SUBJECT: Contract Number W912P8-09-D-0046 0008, WBV-14c.2 - Westwego to Harvey Canal, Hurricane Storm Damage Risk Reduction System, New Westwego P.S. to Orleans Village, Phase 2, First Lift Levee and Floodwalls at Westminster Pumping Station, Jefferson Parish, LA

AMENDMENT OF SOLICITATION/MODIFICATION OF CONTRACT

CO-001 Government Furnished Sheet Piling

Contract W912P8-09-D-0046 0008, WBV-14c.2 - Westwego to Harvey Canal, Hurricane Storm Damage Risk Reduction System, New Westwego P.S. to Orleans Village, Phase 2, First Lift Levee and Floodwalls at Westminster Pumping Station, Jefferson Parish, LA is hereby modified to remove approximately 2,346 SF of Contractor Furnished PZ-27 Sheet Piling and replace with 2,520 SF of Government Furnished PZ-27 Sheet Piling.

SHEET IDENTIFICATION
C-05

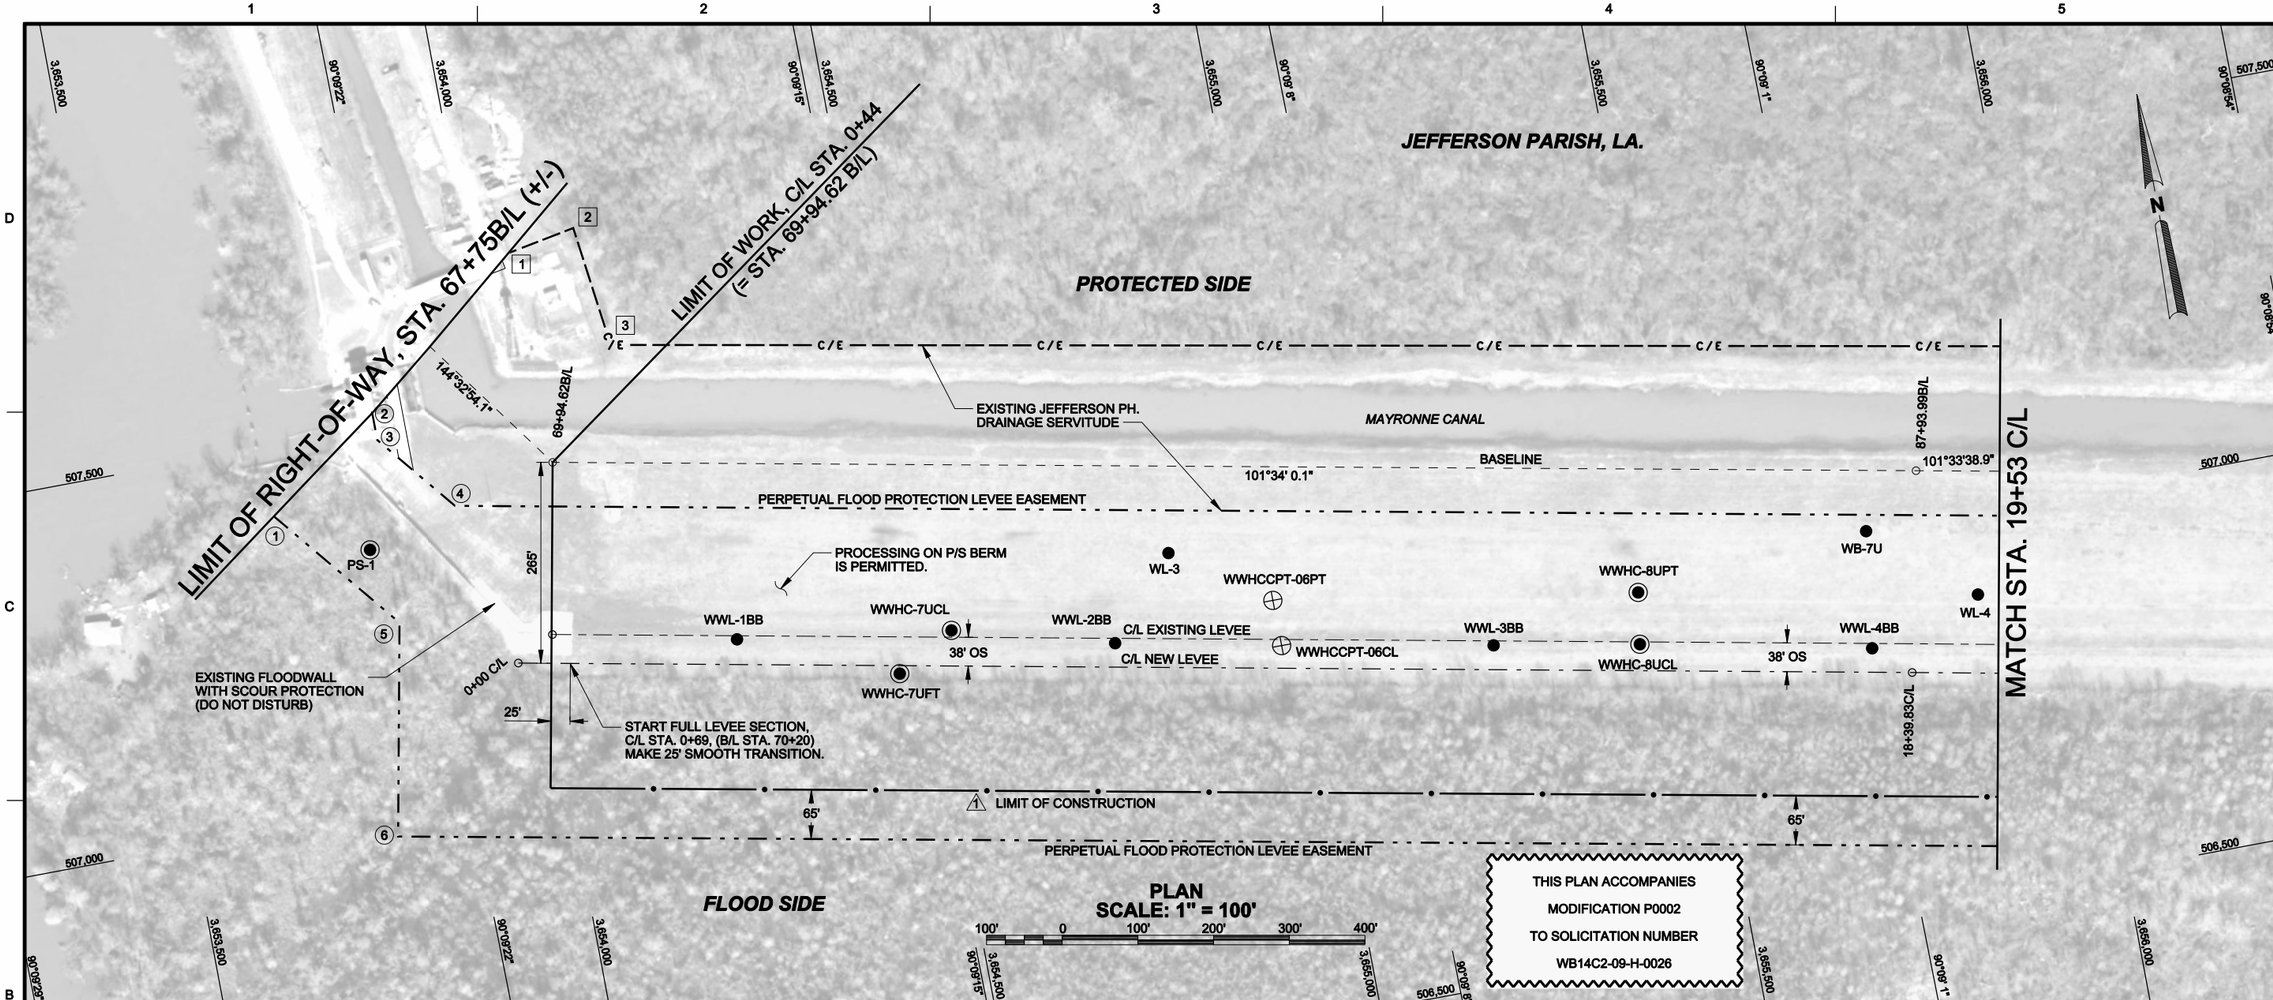
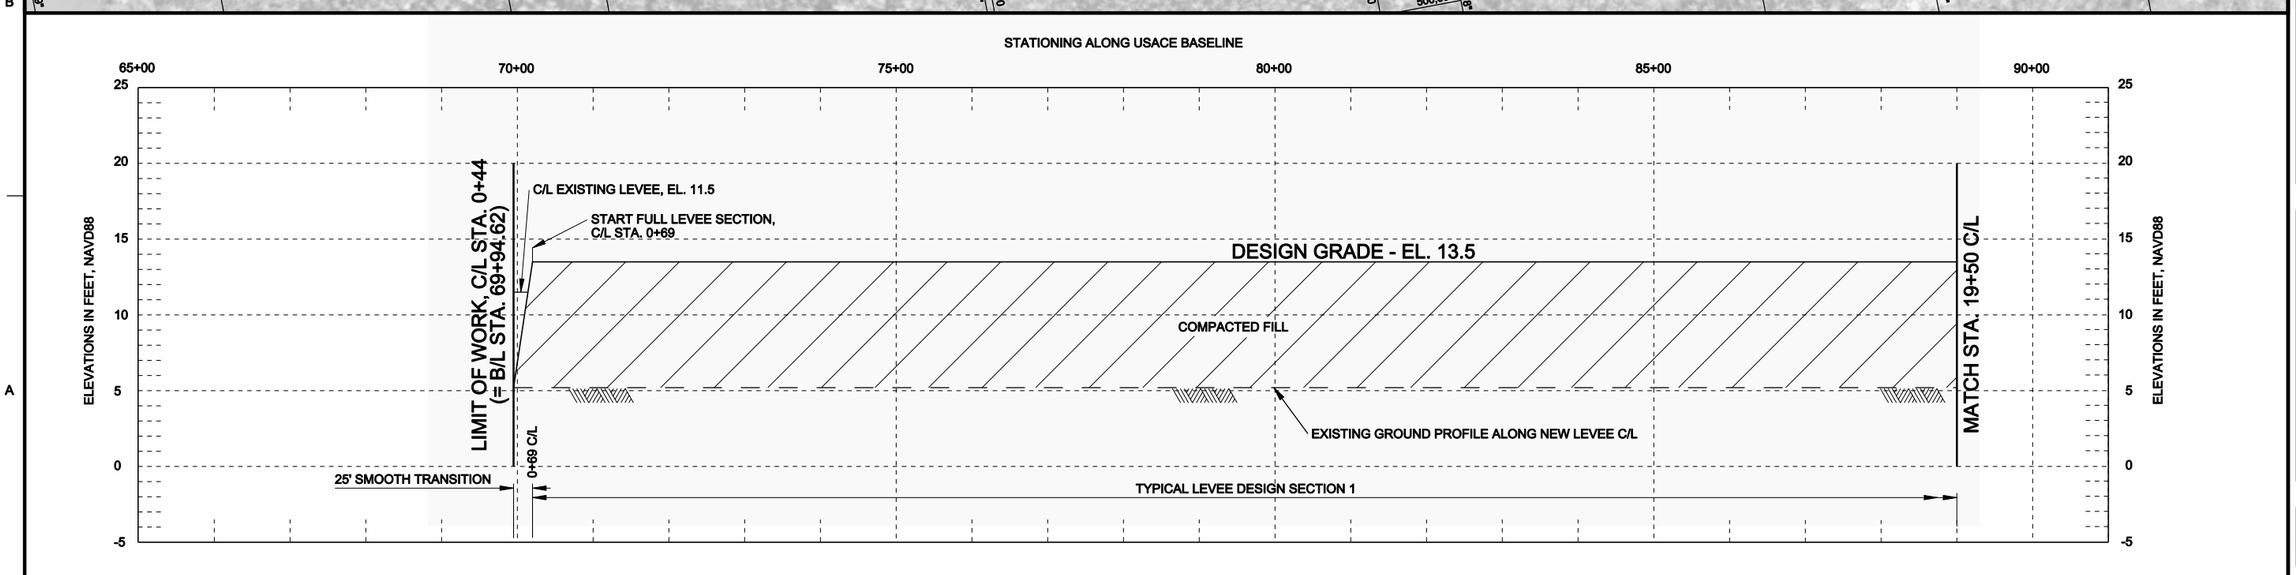
MARK	DESCRIPTION	DATE	APPR.
1	MOD. # P0002 - ADDED FLOOD SIDE LIMIT OF CONSTRUCTION.	04/05/11	B.J.L.

SHEET IDENTIFICATION
C-06

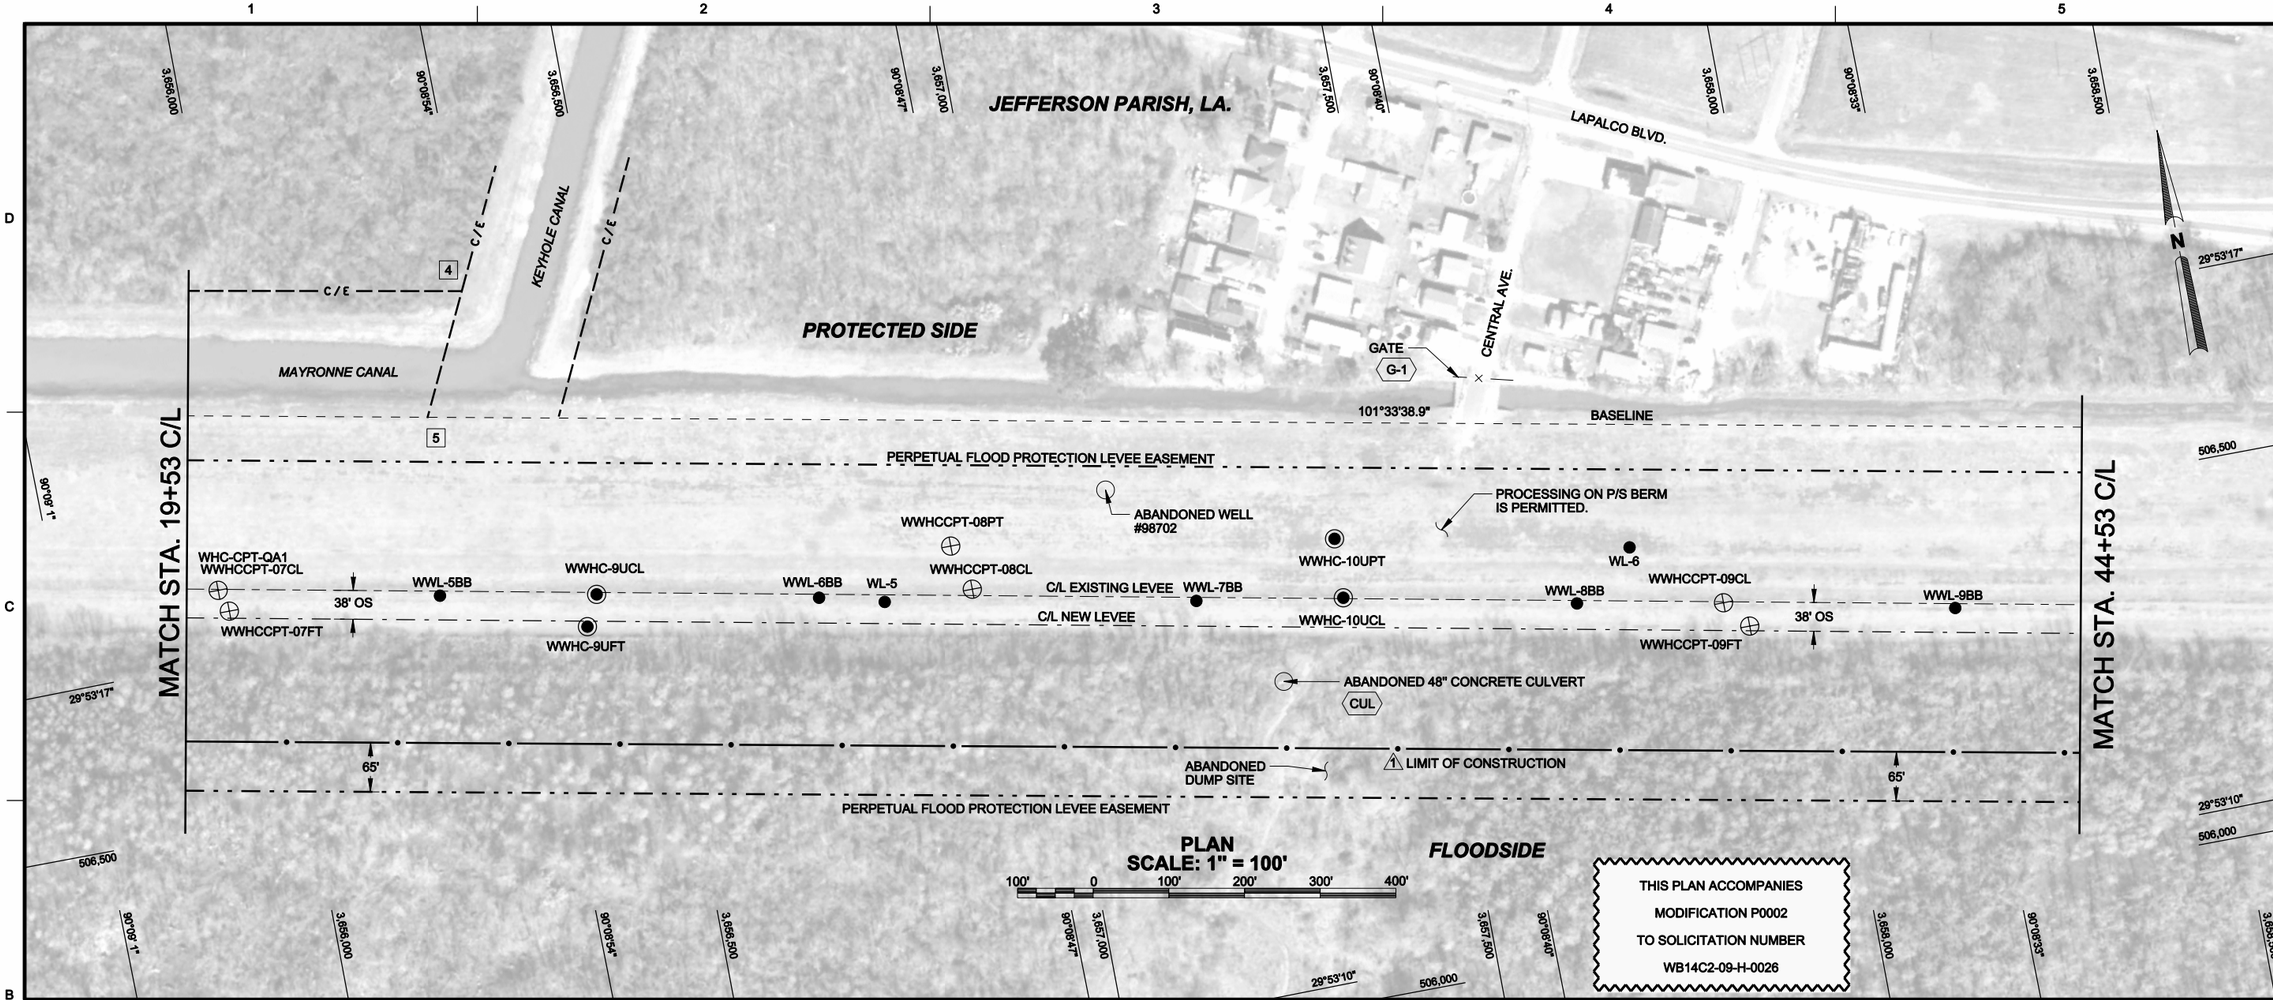
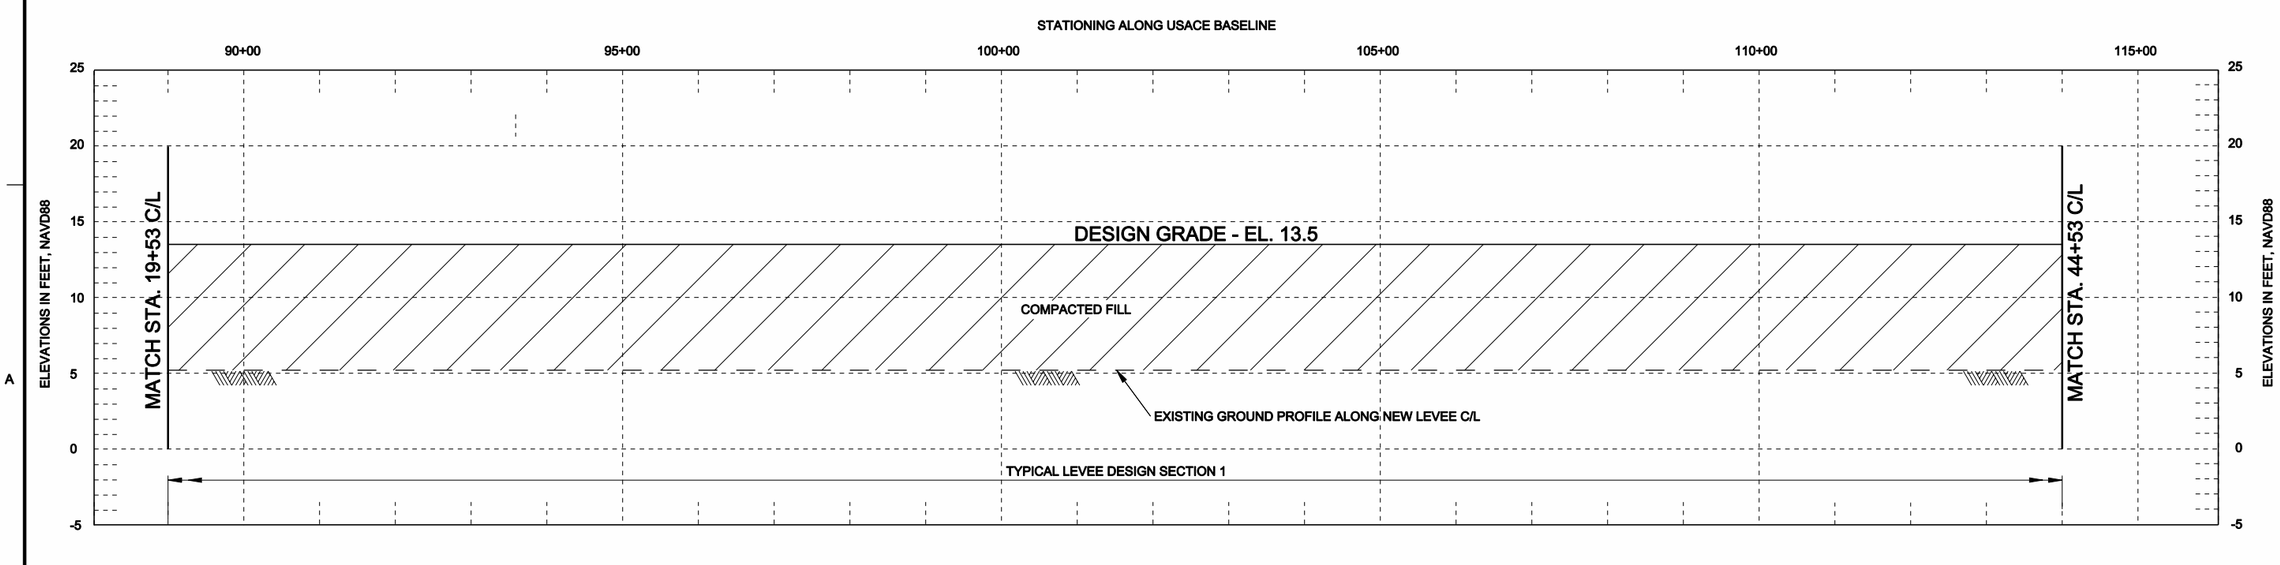
MARK	DESCRIPTION	DATE	APPR.
1	MOD. # P0002 - ADDED FLOOD SIDE LIMIT OF CONSTRUCTION.	04/05/11	B.J.L.

SHEET IDENTIFICATION
C-07

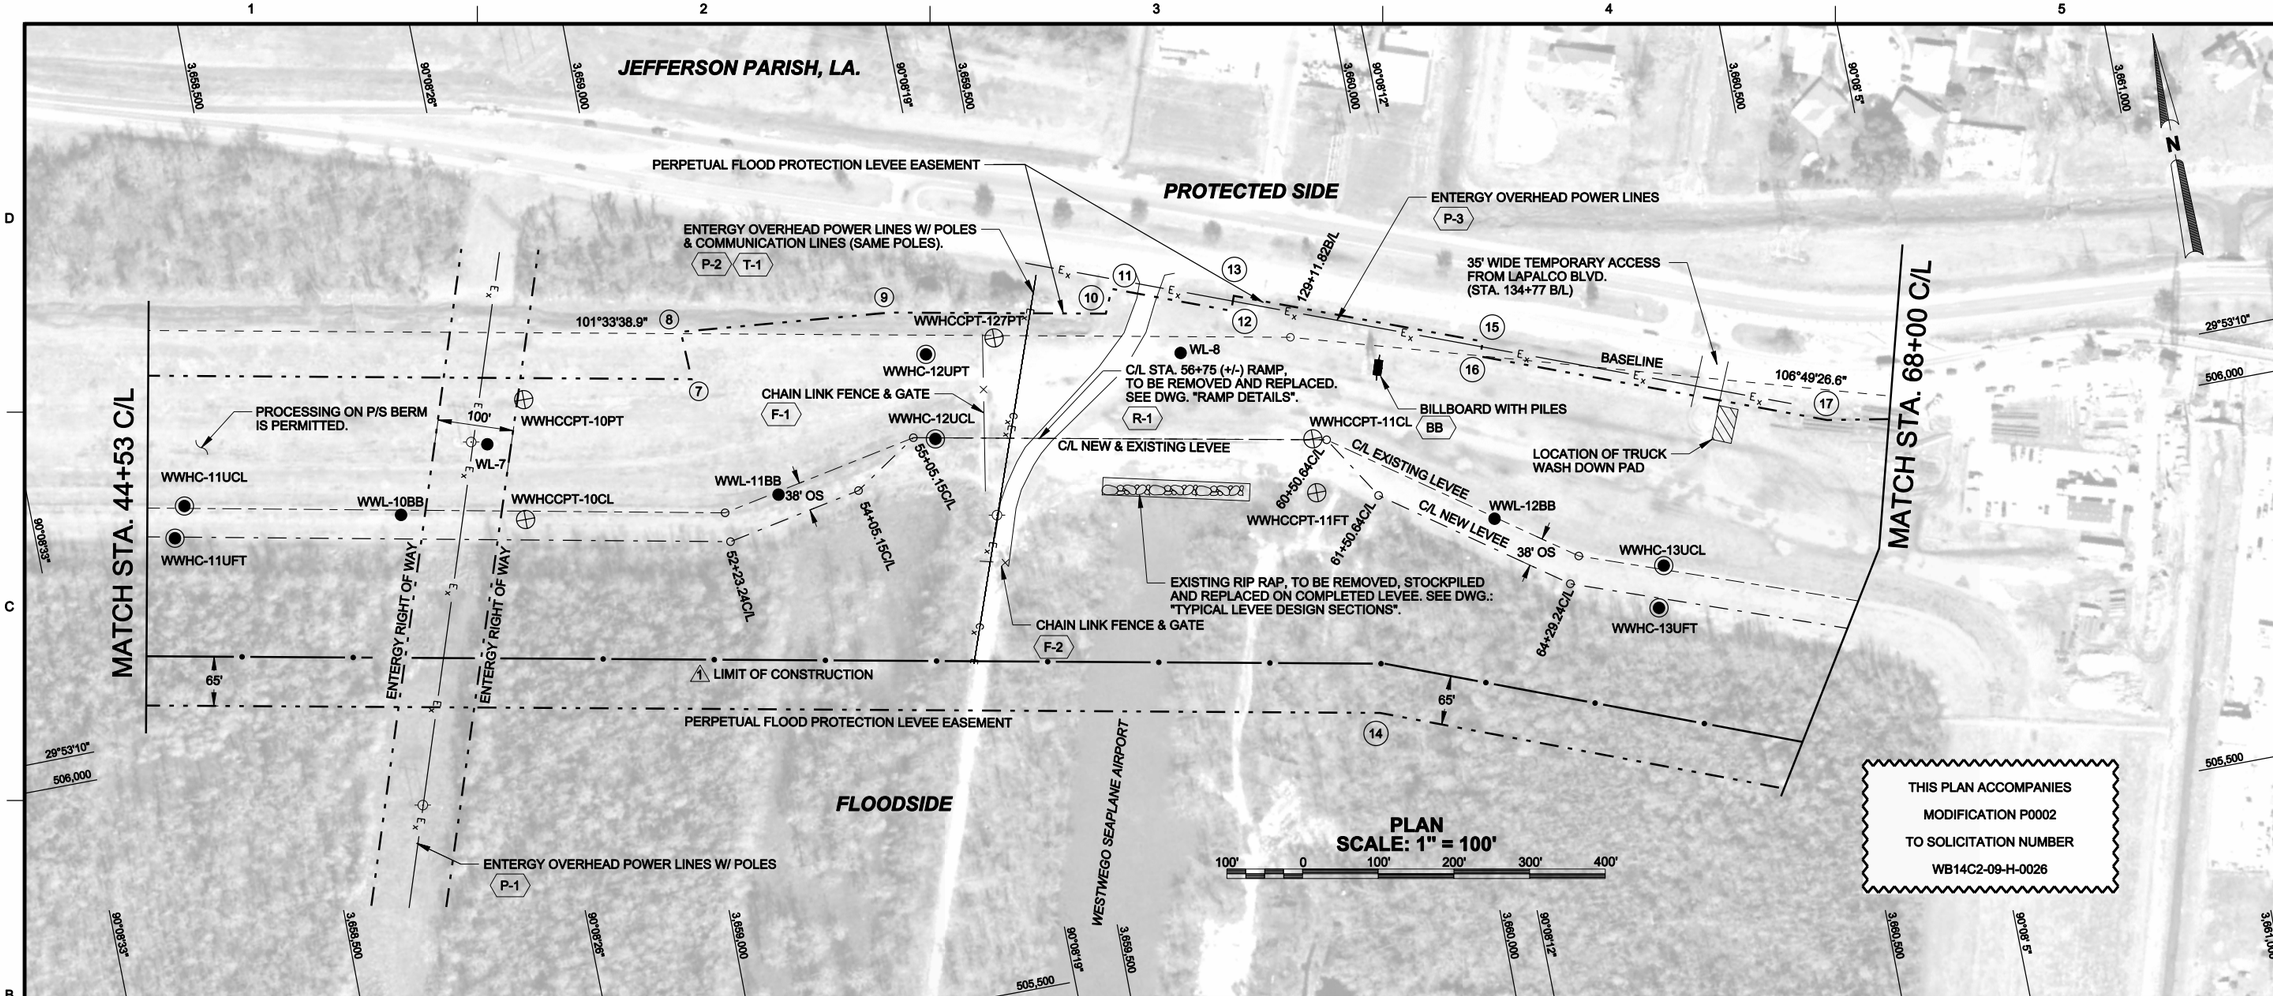
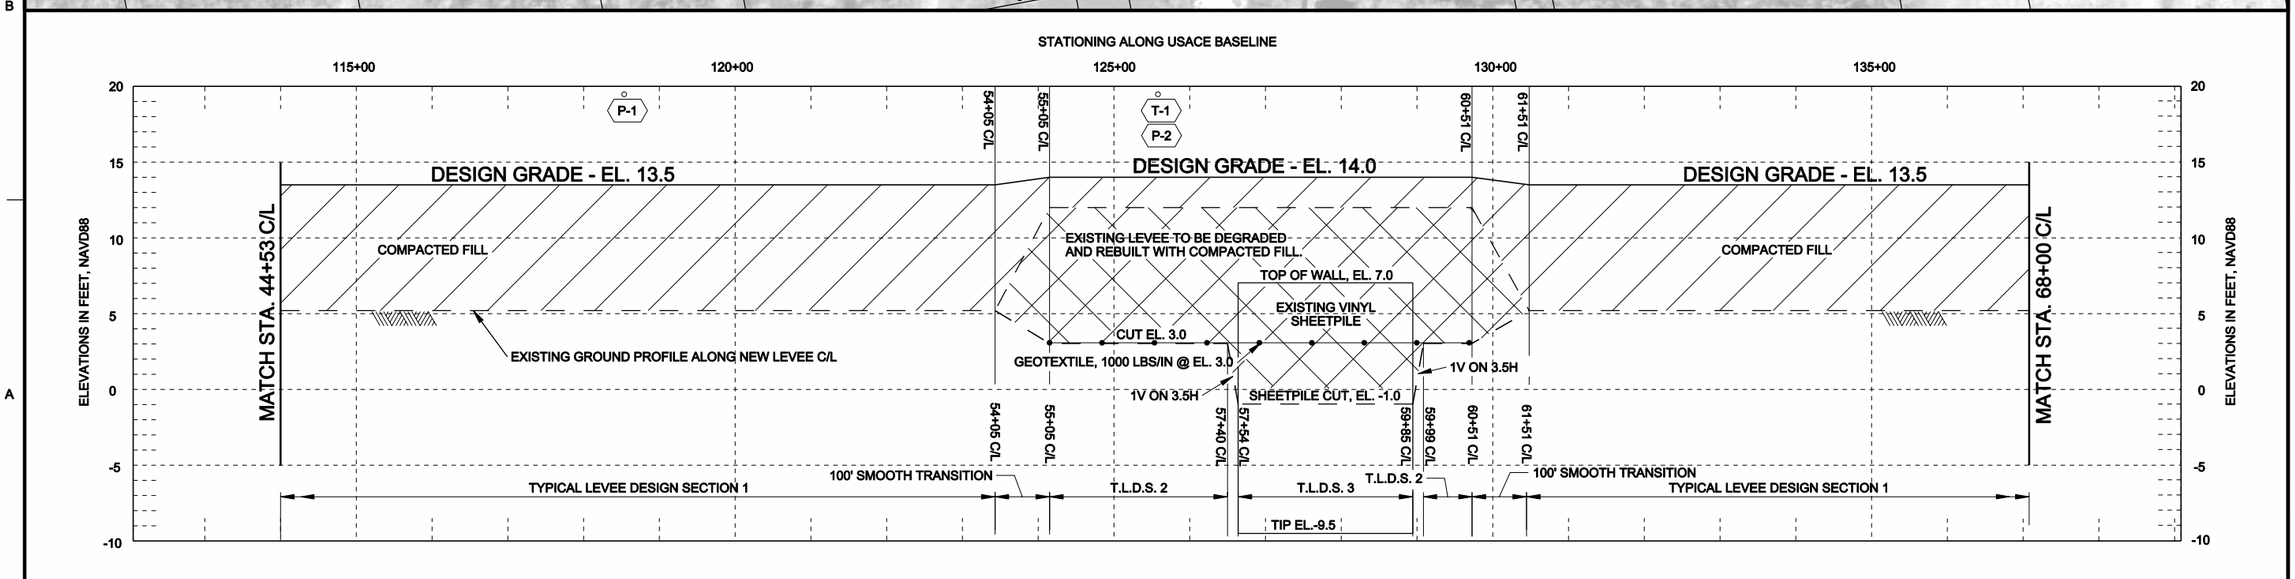
MARK	DESCRIPTION	DATE	APPR.
1	MOD. # P0002 - ADDED FLOOD SIDE LIMIT OF CONSTRUCTION.	04/05/11	B.J.L.
